**325 - 327 Deansgate – Manchester**

Non Material Amendment | 22 August 2022

10185-A-B5D8-RP-DAS-002

## 1.0 Introduction

### Ground Floor Plan

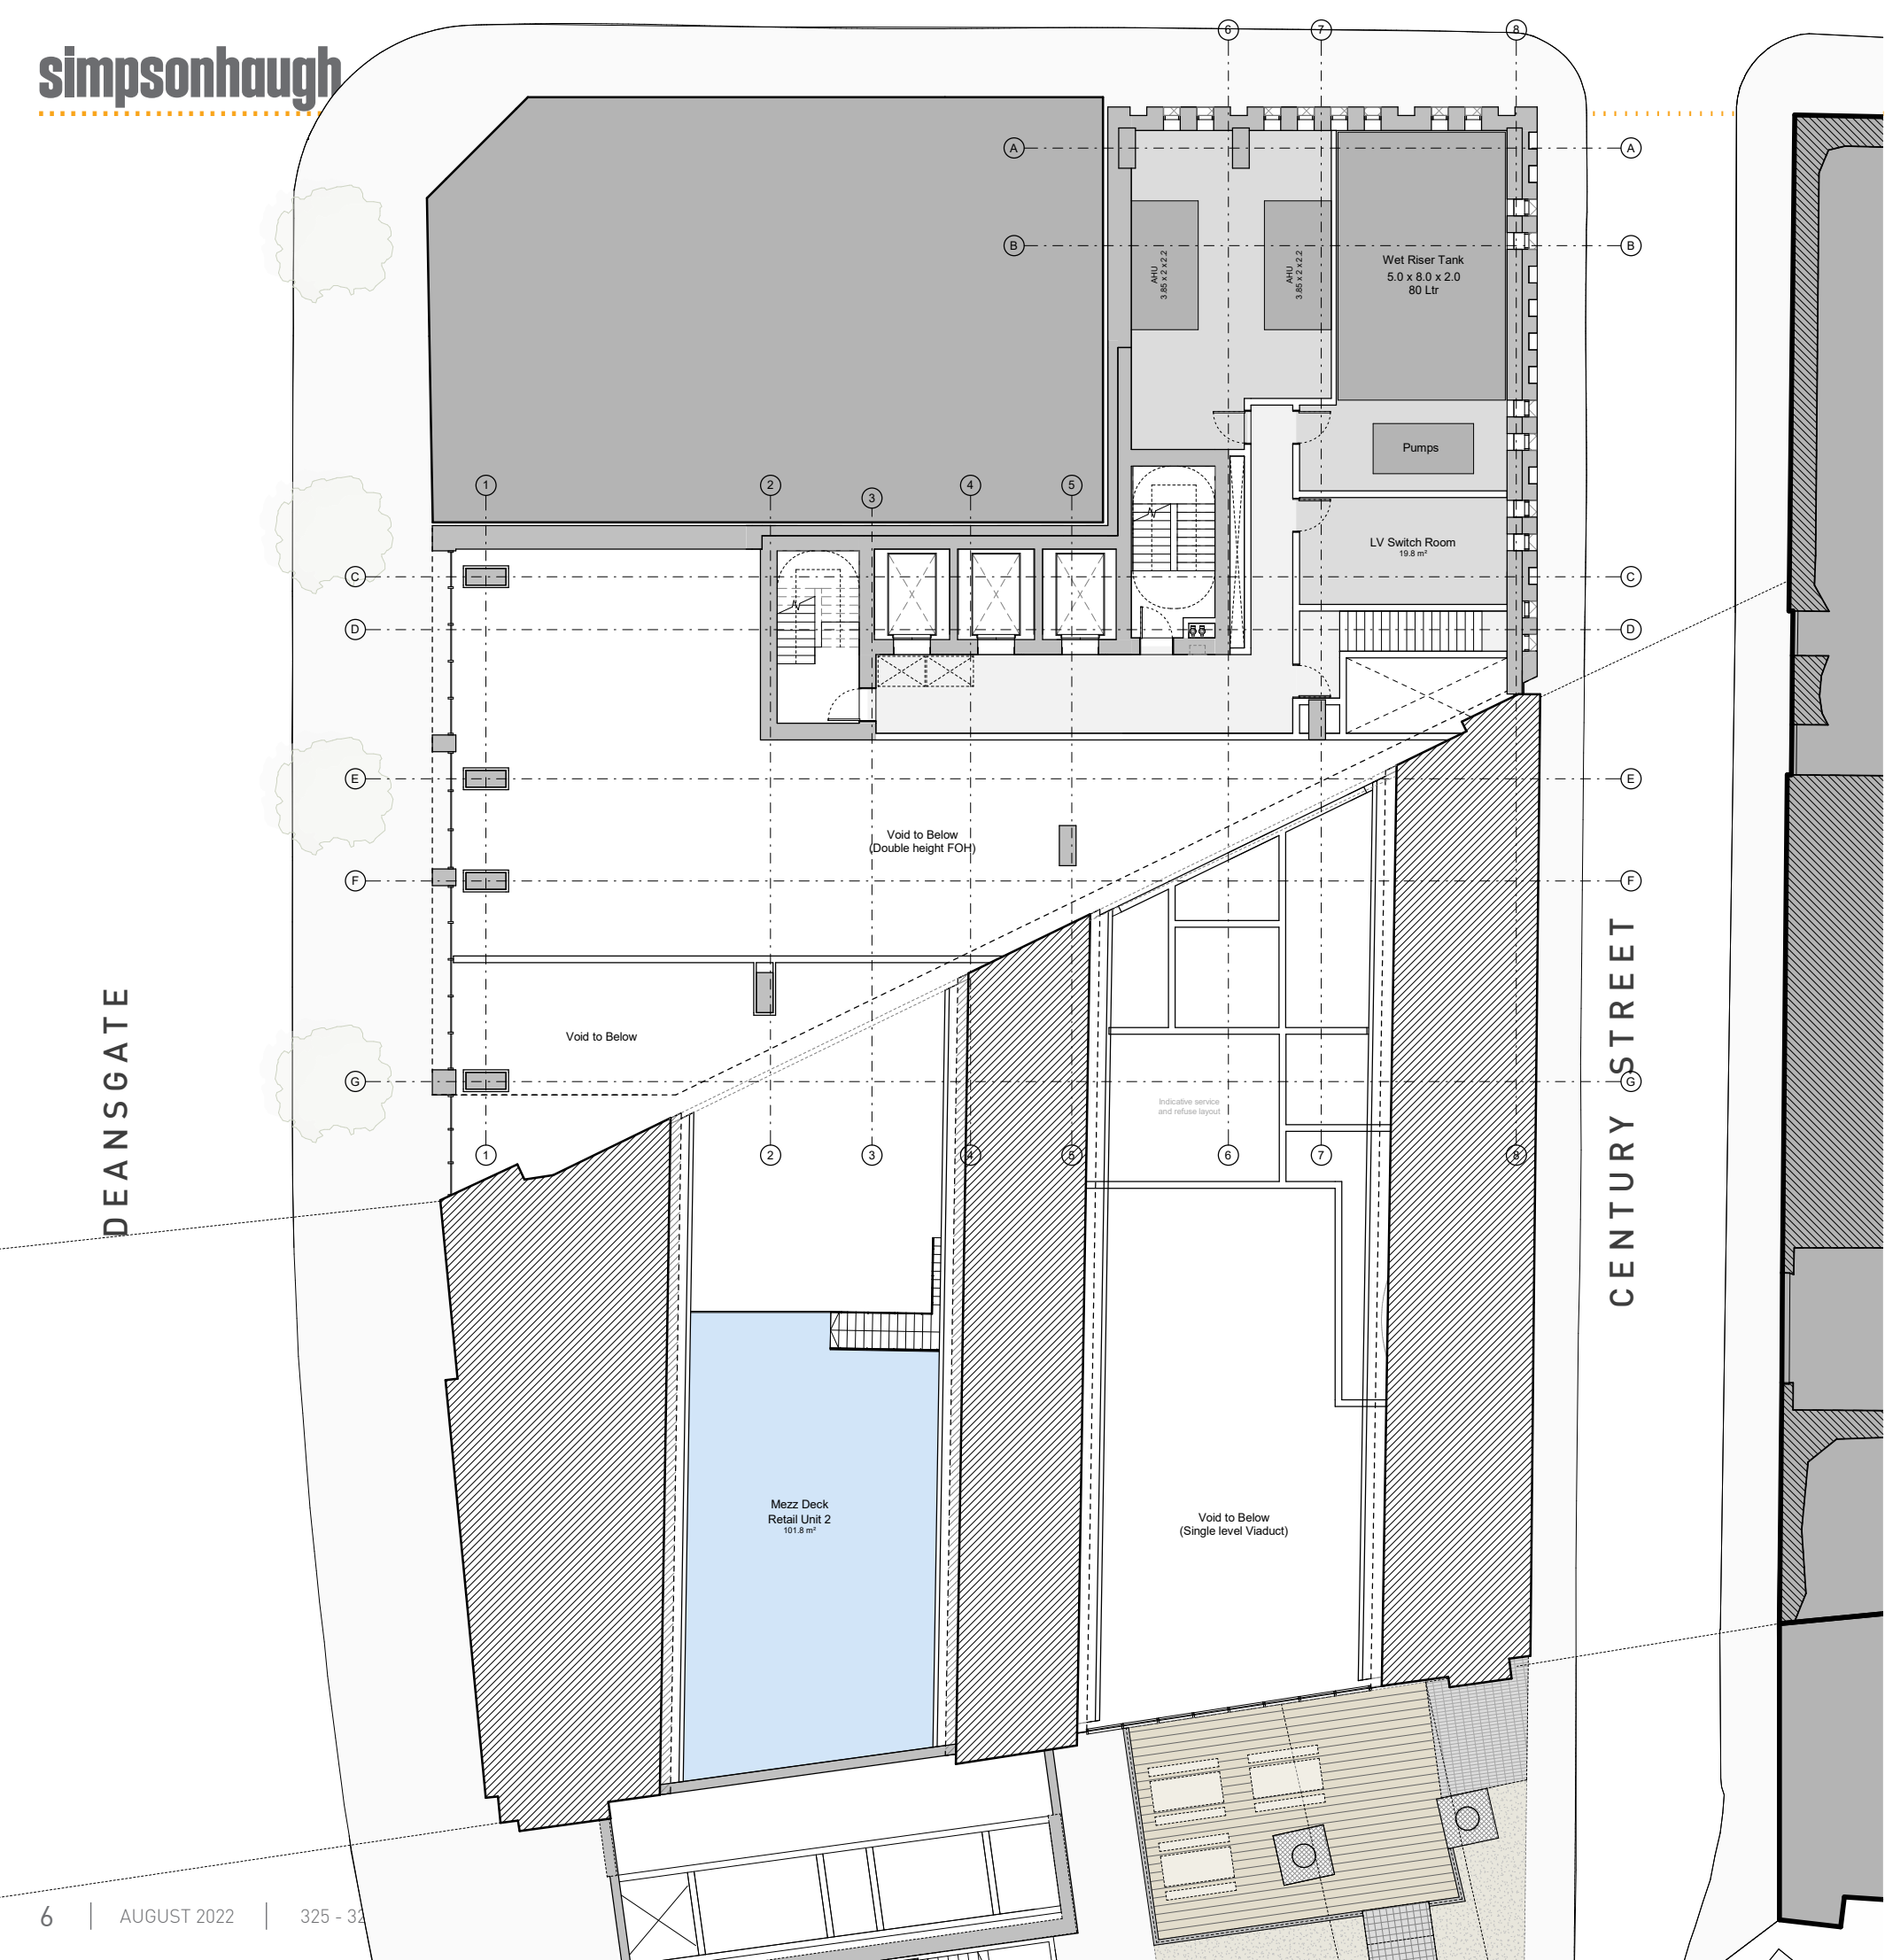
Amendments at Ground floor.

- Commercial Unit 2 omitted
- Hotel restaurant extended into listed arch.
- Minor changes to internal layout, including addition of an extra lift and redistribution of back of house spaces.
- Repositioning of doors on Deansgate frontage

### Mezzanine Plan

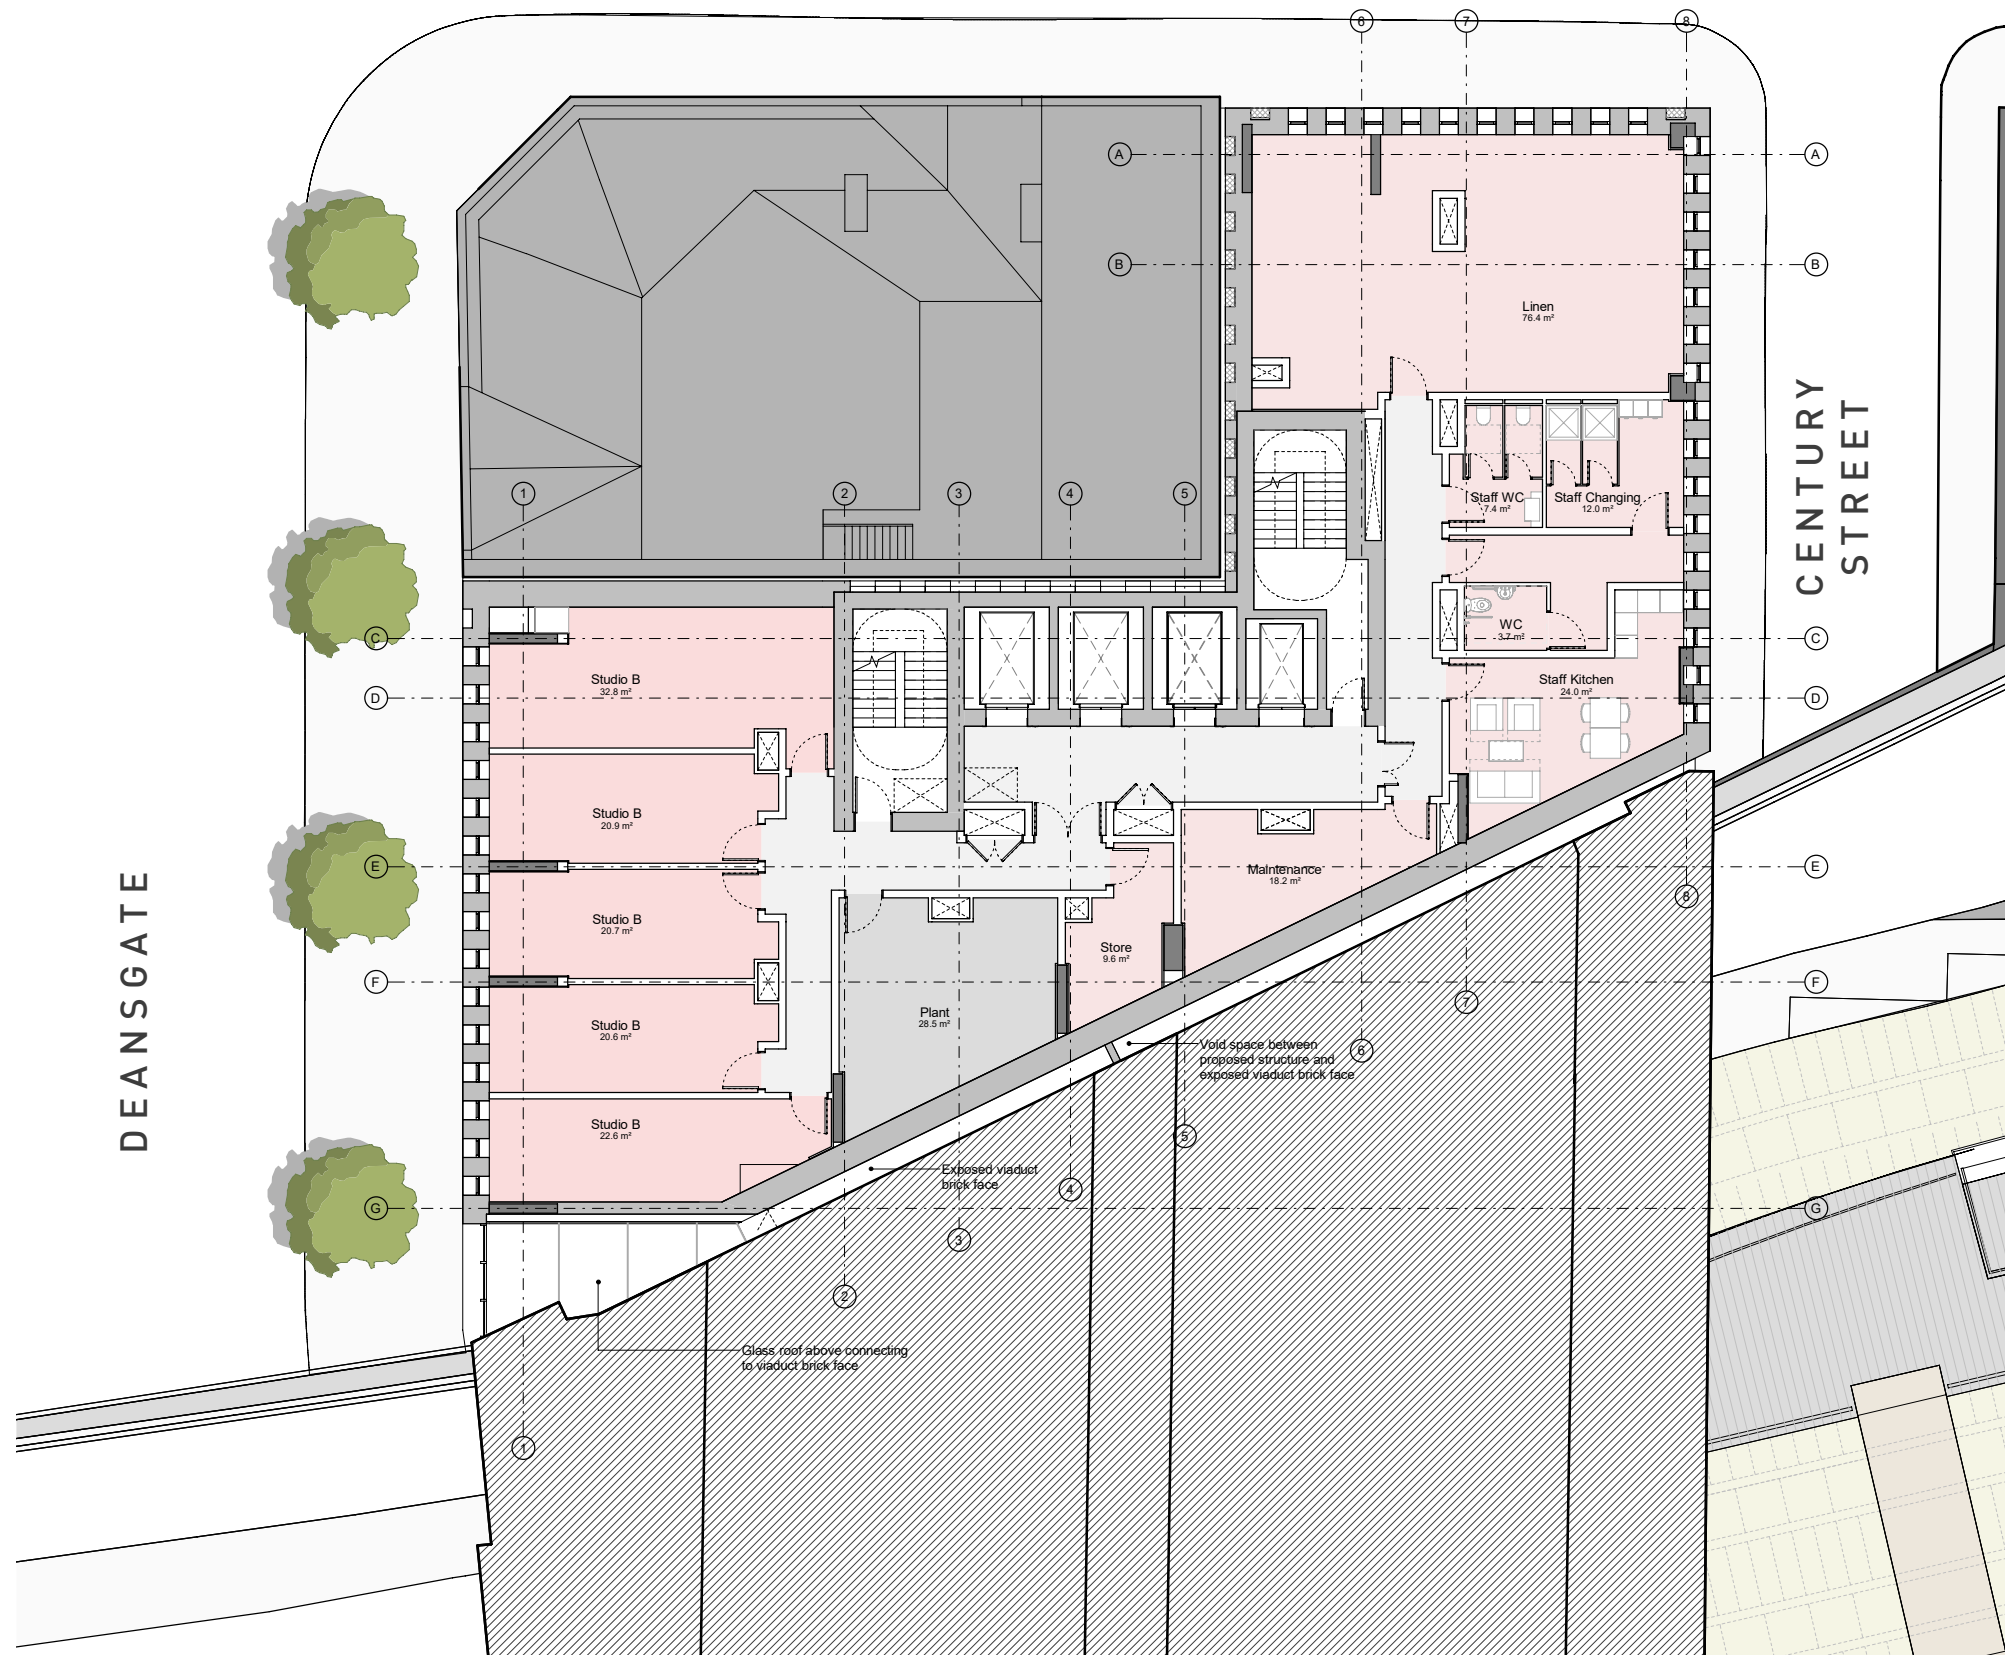
Amendments at Mezzanine level

- Commercial Unit 2 omitted
- Hotel extended into listed arch. Yoga studio included on mezzanine

### First Floor Plan

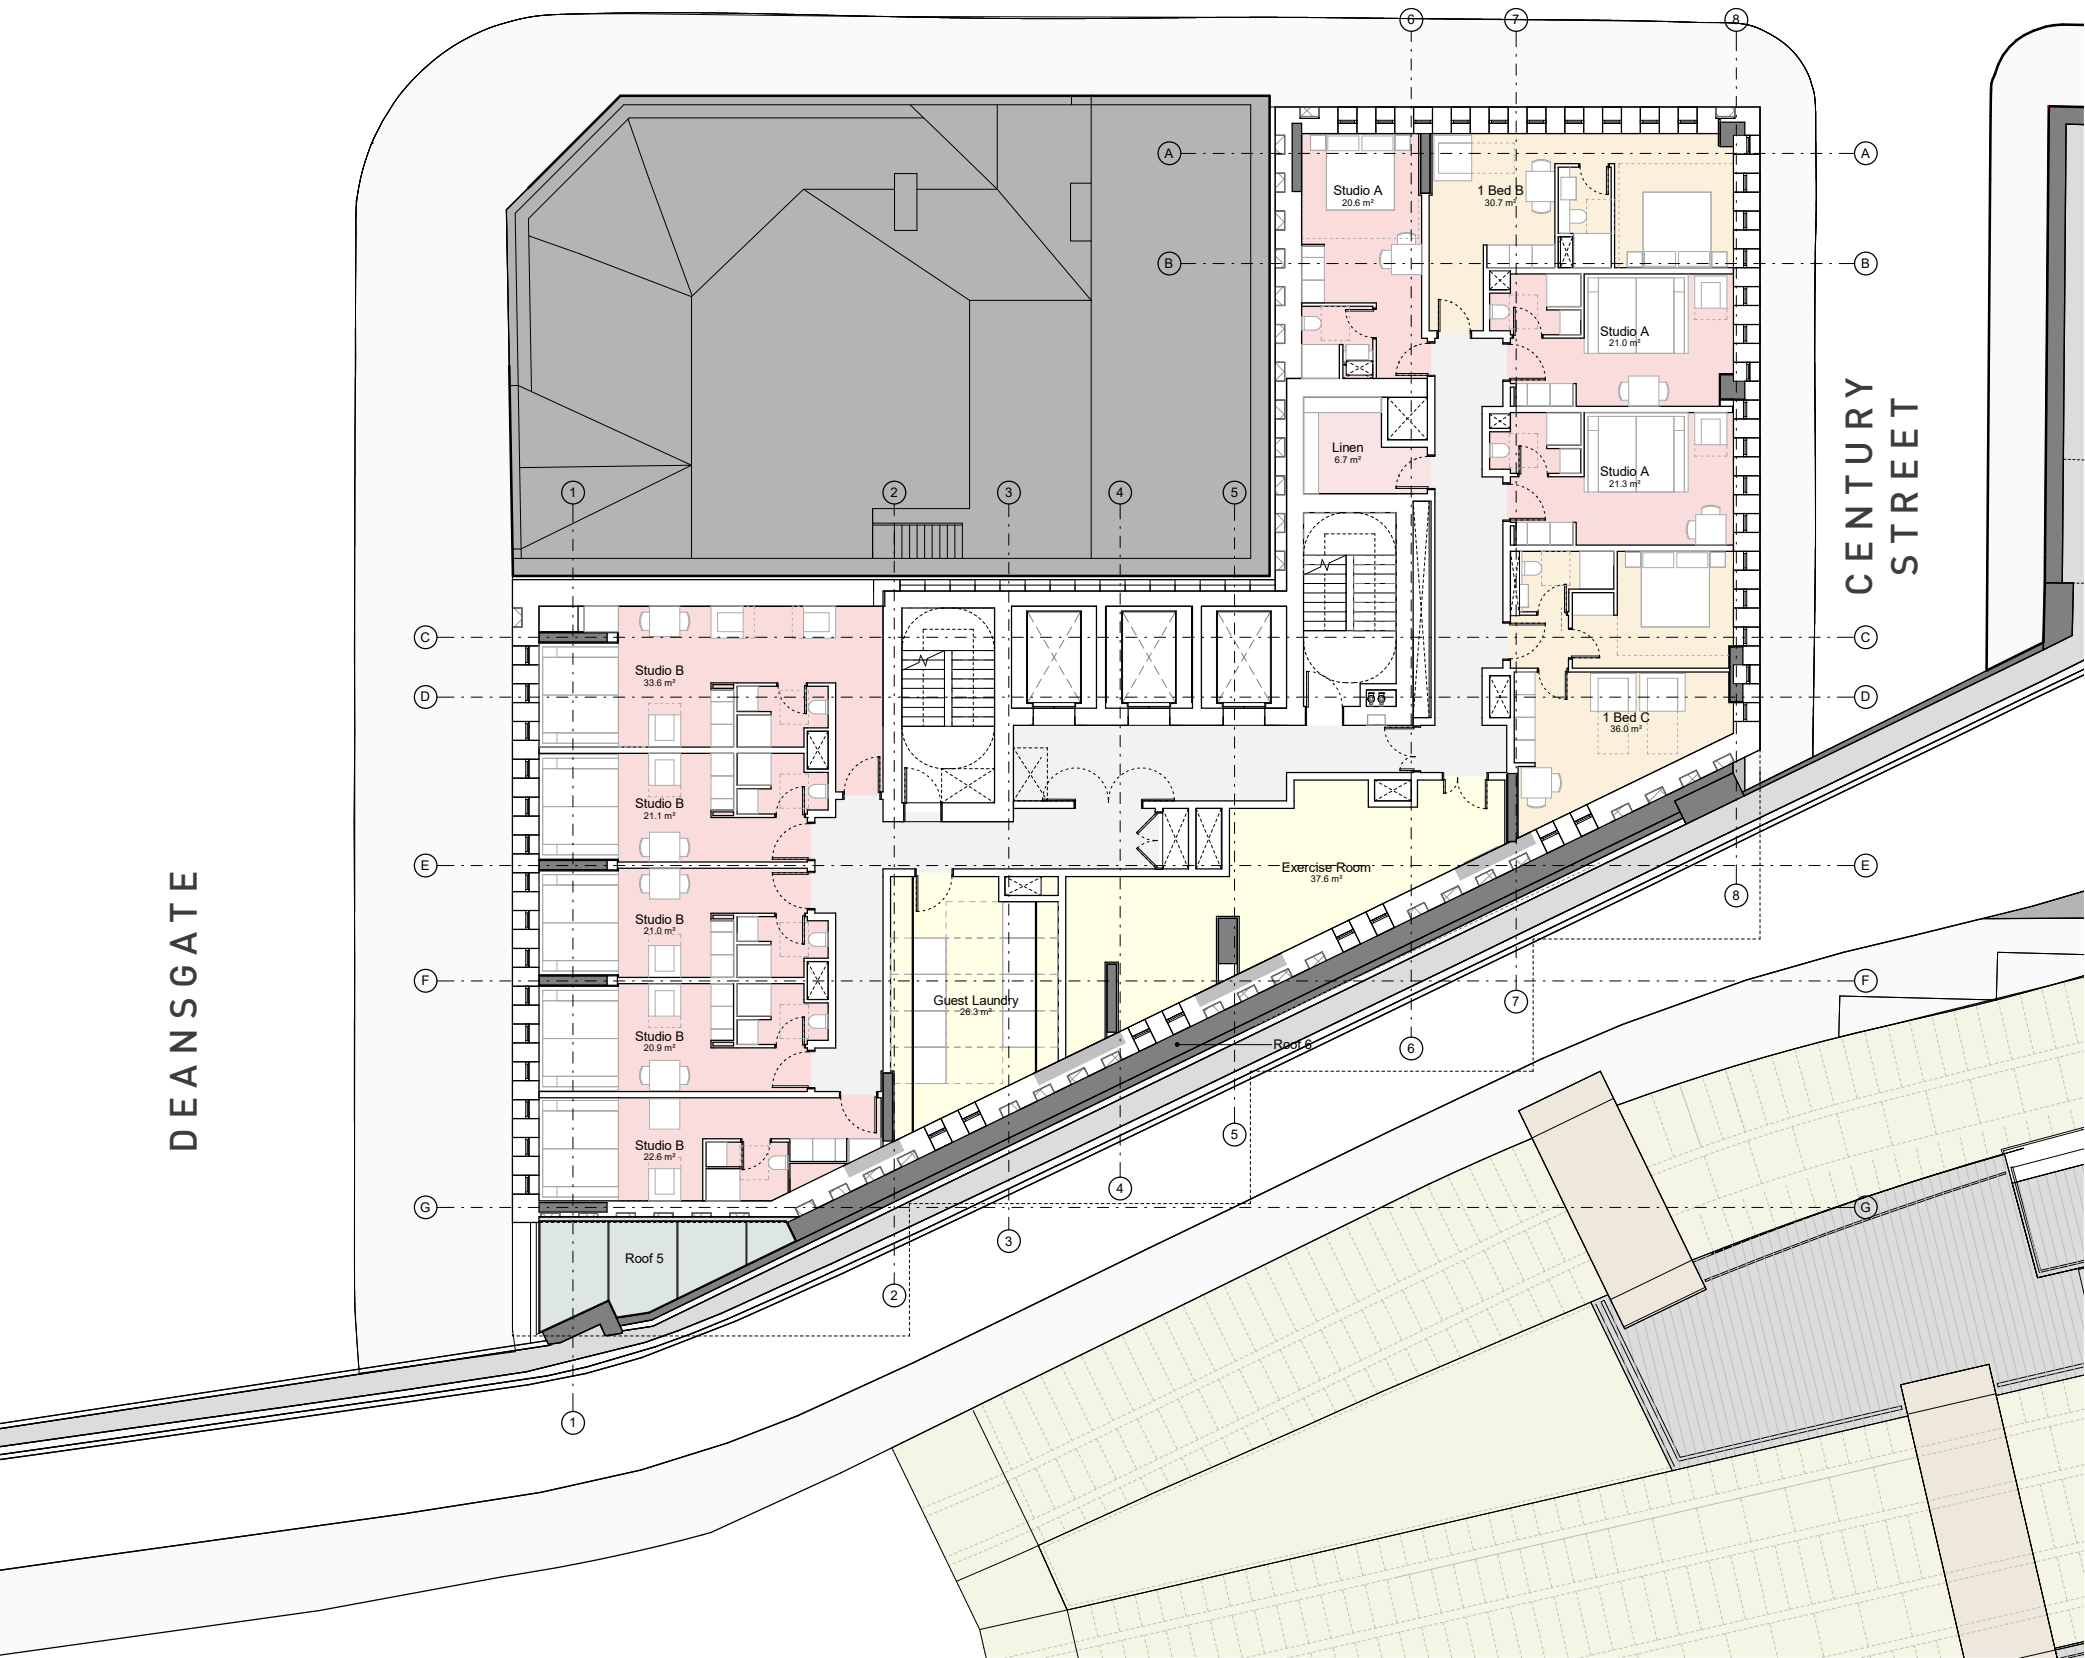
Amendments at First floor.

- Minor changes to back of house layout
